Access Compliance Report

Public Rights-of-Way (Curb Ramps)

Intersection ID: N/A	Main Street: STATESVILLE_AV	Cross Street: OLIVER_ST	Location: NE
ADA ID: 2CD3A30726F7	Ramp Type: Directional1	Initial Pass/Fail: Fail	Overall Compliance: No
		Severity Score: 12.5

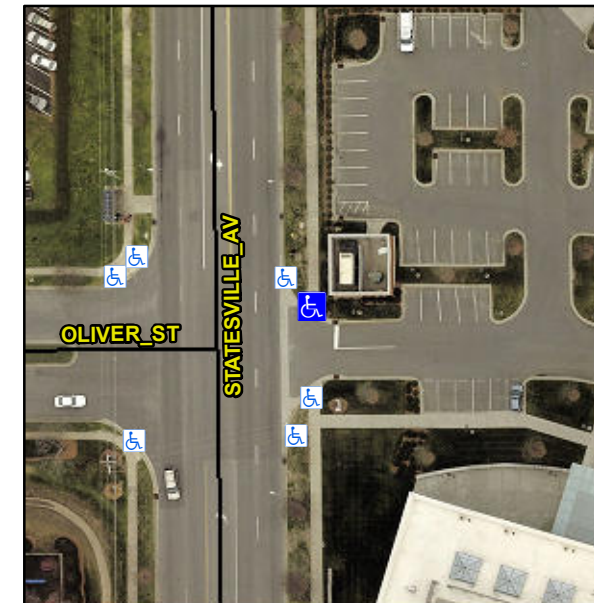
Compliance	Description	Data	Compliance	Description	Data
N/A	Ramp Length (in)	103.0	N/A	Grade Break?	N/A
Yes	Ramp Width (in)	72.0	N/A	Grade Break Slope (%)	0.0
Yes	Ramp Slope (%)	2.3	N/A	Grade Break XSlope (%)	0.0
No	Ramp XSlope (%)	6.4			
N/A	Flare Type LT	N/A	N/A	Flare Type RT	N/A
N/A	Flare Slope LT (%)	N/A	N/A	Flare Slope RT (%)	0.0
N/A	Flare Traversable LT?	N/A	N/A	Flare Traversable RT?	N/A
N/A	Landing Length (in)	0.0	N/A	DWS Provided?	N/A
N/A	Landing Width (in)	0.0	N/A	DWS Contrast?	N/A
N/A	Landing Slope (%)	0.0	N/A	DWS Length (in)	N/A
N/A	Landing X Slope (%)	0.0	N/A	DWS Full Width?	N/A
N/A	Landing Curb? (Y/N)	N/A	N/A	DWS Offset LT (in)	N/A
N/A	Shared Landing?	N/A	N/A	DWS Offset RT (in)	N/A
N/A	Gutter Ponding?	0.0	N/A	Gutter Slope (%)	N/A
N/A	Gutter Lip Ht (in)	0.0	N/A	Gutter X Slope (%)	N/A
N/A	Painted X Walk1?	No		Road Slope (%)	1.7
	X Walk 1 Direction	To S		Road X Slope (%)	6.1
	X Walk 1 Width (in)	N/A		Clear Space?	N/A

Remove & Replace Entire Ramp.

R304.5.3
